UNITED STATES PATENT AND TRADEMARK OFFICE

APPLICATION NO.	FILING DATE	FIRST NAMED INVENTOR	ATTORNEY DOCKET NO.	CONFIRMATION NO.
10/800,727	03/16/2004	Atsushi Hirota	118925	1036
25944 7590 07/22/2008 OLIFF & BERRIDGE, PLC P.O. BOX 320850 ALEXANDRIA, VA 22320-4850				
EXAMINER				
FIDLER, SHELBY LEE				
ART UNIT		PAPER NUMBER		
2861				
MAIL DATE		DELIVERY MODE		
07/22/2008		PAPER

Office Action Summary

DETAILED ACTION

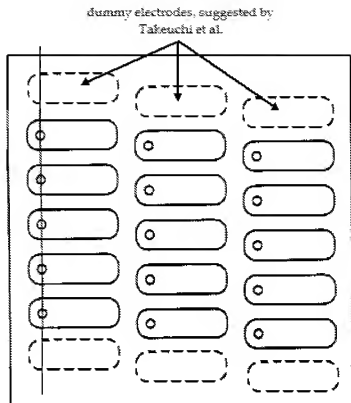
Therefore, at the time of invention, it would have been obvious to a person of ordinary skill in the art to modify Takahashi's actuator unit to include dummy electrodes spaced in an outward direction from the individual electrodes, such that one of the dummy electrodes is spaced from Takahashi's outermost individual electrode with respect to two arrangement directions of the plurality of individual electrodes (see Drawing A below).

Takahashi as modified by Takeuchi et al. discloses all the limitations of claims 1/15, and **the combination of Takahashi as modified by Takeuchi et al. also suggest** that each of the individual electrodes, other than the outermost one with respect to one of the two arrangement directions, is surrounded with corresponding ones of the individual electrodes arranged in a predetermined pattern (Drawing A); and wherein the outermost one of the individual electrodes with respect to the two arrangement directions of the plurality of individual electrodes is surrounded with a corresponding one of the individual electrodes and a corresponding one of the dummy electrodes arranged in substantially the same pattern as the predetermined pattern (Drawing A).

the combination of Takahashi as modified by Takeuchi et al. also disclose that a plurality of the dummy electrodes are arranged adjacent to each other so as to surround the plurality of individual electrodes arranged adjacent to each other in a matrix (Drawing A).

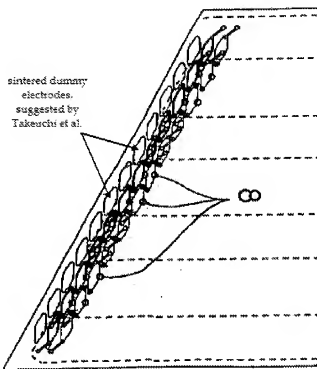
Therefore, at the time of invention, it would have been obvious to a person of ordinary skill in the art to modify Sakaida's actuator unit to include sintered dummy electrodes arranged adjacent to each other so as to surround the plurality of individual electrodes (Drawing B below).

Sakaida as modified by Takeuchi et al. discloses all the limitations of claim 21, and **Takeuchi et al. also suggest** that the sintered dummy electrodes are spaced from the outermost one of the individual electrodes with respect to two arrangement directions of the individual electrodes (Drawing B), and

wherein the two arrangement directions are formed in intersecting planes (Drawing B).
